TELIANDER OF EM 2000 AND REP		700, PLETTENDERG DAT, WESTERN CAPE	
	PRE-APPLICATION BAR COMMENTS		
COMMENT	NAME/ORGANISATION	RESPONSE	#
1. The pre-application Basic Assessment Report (Ref:	Steve Kleinhans		1
MLKW/EXP/PB/06/24) dated 5 September			
2024compiled on your behalf by your appointed	Department of		
registered Environmental Assessment Practitioner	Environmental Affairs		
("EAP"), Mr. Michael Bennett (EAPASA No: 2021/3163)	and Development		
and assisted by Candidate EAP, Ms. Lu-Anne de Waal	Planning Directorate:		
(EAPASA No: 2024/7962) of Sharples Environmental	Development		
Services cc, as received by the Directorate:	Management, Region		
Development Management (Region 3) ("this	3.		
Directorate") on 12 September 2024, refers.

THE PROPOSED EXPANSION OF MILKWOOD MANOR HOUSE AND PARKING ON ERF 10190, REMAINDER OF ERF 2066 AND REMAINDER OF ERF 706, PLETTENBERG BAY, WESTERN CAPE

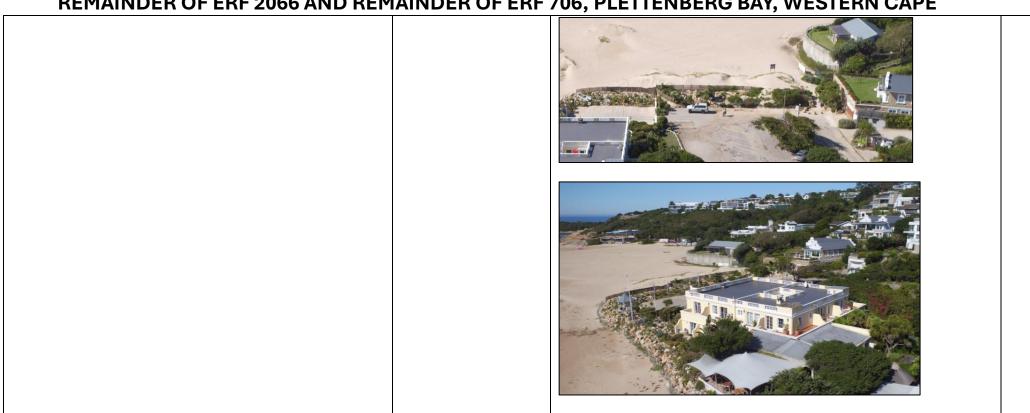
With due consideration of the above, this Directorate is of the considered view that the proposed beach shower deck will be located in the LAZ. Therefore, the placement of the proposed shower deck will prevent the free movement of sand within the LAZ. The information provided in the pBAR suggests that the proposed shower deck will exceed 10m2. Therefore, you are advised to consider the inclusion of EIA Regulations, 2014 Listing Notice 1 (Government Notice No. R. 983 of 4 December 2014, as amended) Activity No. 18 in the application for environmental authorisation.

We do understand the apprehension for the placement of the showers in the LAZ, however when looking at the proposed area holistically and taking the images below of the site into consideration one can conclude that the location of the site is in fact located in a wind shadow created by the surrounding landscape and structure. Deposition of sand mainly occurs at this location so instead of erosion there will be more of a maintenance requirement to keep the shower deck clear of sand periodically.

Additional, as mentioned in our previous response, the LAZ will not be compromised, and the public will be far safer showering on the beach instead of in the carpark.

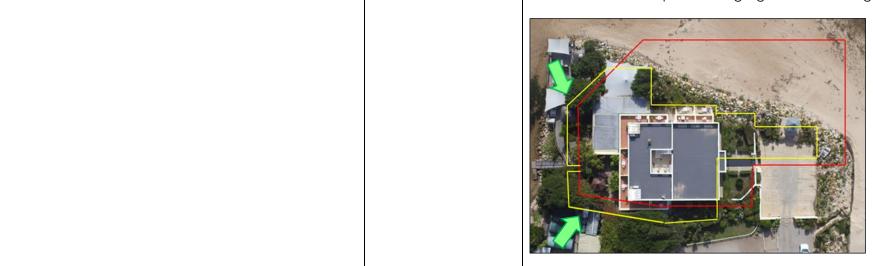
2.1.17. Be advised that the entire subject area is located in	these public amenities, these amenities are still present on the alternative layout. As mentioned in a previous response, the mitigation measures	33
the estuarine functional zone ('EFZ') which equates to the 5m contour along an estuary, and it encapsulates the most dynamic areas influenced by long-term estuarine sedimentary processes. It also provides a buffer zone that	recommended by the Coastal Engineer have been incorporated into the designs to mitigate these potential impacts as much as possible.

allows an estuary to swell within the floodplain of an estuary in the event of flood events, inundation as well as sea-level rise due to climate change. It allows for the inclusion of some terrestrial fringe vegetation that contribute detritus to the system and refuge areas for many animal species during floods. It must be noted that in general the SD: CM does not support any development within EFZ however the development island is recognised for Erf 10190, but the applicant must note their property is still at risk to coastal processes and therefore it is advised that caution be applied in considering any expansions to the property.

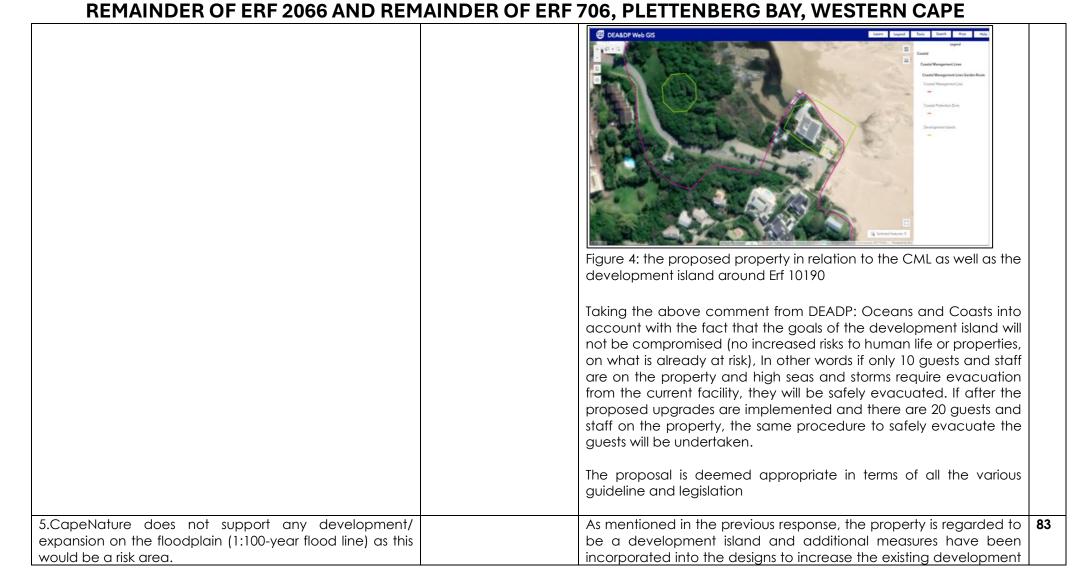
3. CapeNature does not support any clearing of vegetation that will destabilize the banks of the estuary. However, we do recommend bank stabilization to mitigate the impacts of future storm events.	We agree that destabilising the banks of the estuary should not be undertaken and does not form part of this proposal. Vegetation clearance proposed outside of Erf 10190 is only to construct the	81

additional parking areas as shown in the layout plans and the Image below extracted from the estuarine Assessment Report.	
4. Enhancements of existing rights should not be allowed; however, maintenance of existing approved infrastructure	above: a development island is considered outside or landward of	
can be.	the CML in order to recognise existing development rights. In this regard, all the proposed activities within the boundaries of Erf 10190 falls within the development island and thus landward of the CML. Furthermore, all proposed activities directly south of Erf 10190 are also considered landward of the CML (see Figure 1 below). However, it must be noted that the development islands is to limit the enhancement of existing development rights and/or the expansion of development within these development islands in order to reduce risk of human life and properties as a result of coastal processes and impacts of climate change."

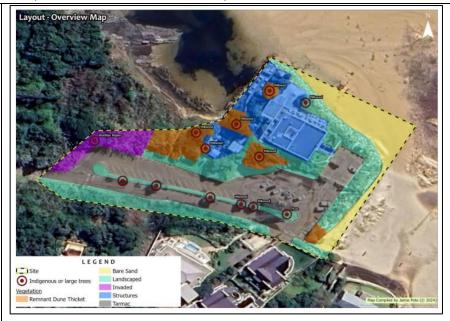
Forestry request that the proposed extensions- as well as the proposed layout incorporate the protected trees. Protected trees to be retained and indicated as no-go areas A National Forestry Act Licence application will be undertaken before these trees are disturbed.

The terrestrial biodiversity specialist has mapped the protected Milkwoods on site and as seen in the combined layout with potential trees below, Milkwoods will have to be removed to undertake the expansion. The specialist has assessed the removal of the trees and found that these remnant Milkwood trees do not perform any substantial ecosystem service and will not have any significant impact to the broader conservation of the species
